Response to anonymous referee RC1 on "Assessment of Sub-Shelf Melting Parameterisations Using the Ocean-Ice Sheet Coupled Model NEMO(v3.6)-Elmer/Ice(v8.3)" by Favier et al.

April 26, 2019

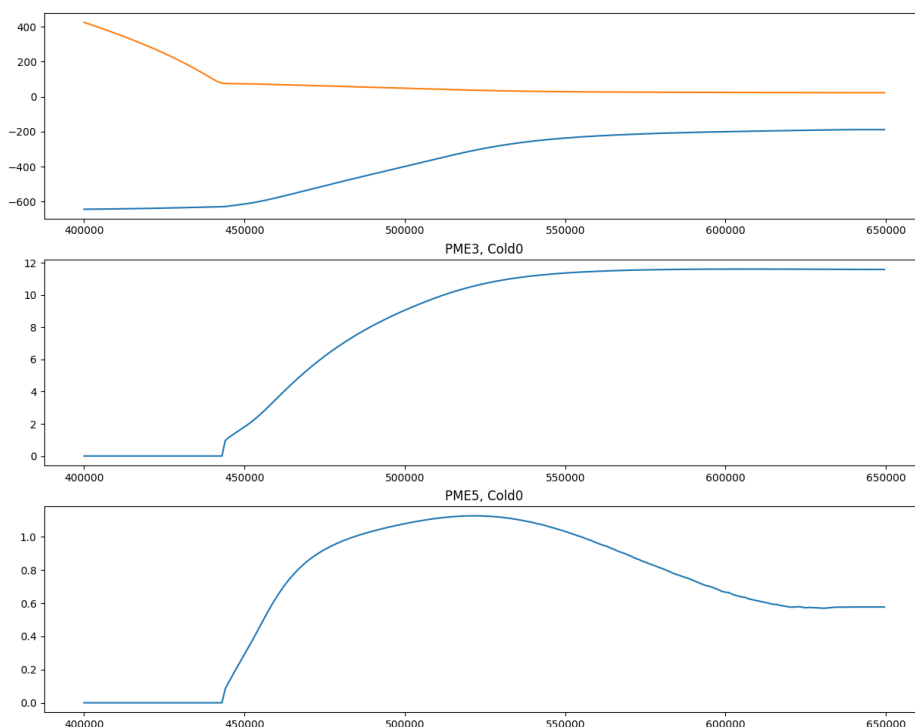
- Plume parameterization: More detail is needed: the explanation of why the melt rates show this pattern of no melting near the grounding line and then increase towards the calving front without a melt-peak and decline afterwards is unclear to me, see also comment on page 17, lines 6-9. Given that its effective grounding line depth is always the central grounding line, I would expect the PME3 parameterisation to yield results along the center line $y = 40\text{km}$ that are similar to a line plume model. In Figure 8 (g) of Lazeroms et al. 2019 (doi:10.1175/JPOD-18-0131.1) melt rates calculated with a comparable plume parameterisation and with a full plume model are shown for PIG with a melt rate peak around 15km and a decrease afterwards. Is this pattern different from the pattern you find here because of the higher T_0 value used (1 degree at depth versus -1 degree)? If yes, how could this be improved?

[This is a very interesting remark as it highlights the effect of the different choices in the implementation of the plume parameterisation. The PME3 accounts for the slope between the grounding line and the draft point as the effective angle, while the approach of PME1 \(that is developed in Lazeroms et al, 2018, and also in the Lazeroms et al, 2019\) accounts for the local slope. The two curves are thus difficult to compare, and also because they are the result of different environmental conditions of geometry, ambient temperature and salinity. In that sense, Fig. 8g of the Lazeroms et al, 2019, may not be the best to be compared with. Here below, you will see Fig. 1, which represents PME3 and PME5 \(Fig C1 and Ap. D of the paper\). The difference between PME3 and PME5 is in the definition of the effective slope, the local gradient being considered in PME5 instead of the slope between the grounding line and the draft point. We have chosen to represent the \$Cold_0\$ in Fig. 1 because the temperature of -1.5 is closer to -1.9 used in Lazeroms et al, 2019 \(maybe you can consider their Fig. 5d to be compared with\). To keep the paper clear, we have decided not to give those technical details](#)

in the paper. And, to conclude, we do have a melting peak in our simulations but the melt rates distribution will depend on the way the effective slope is accounted for, the temperatures, the thickness at the calving front, among other things, which for us opens the road to further investigations.
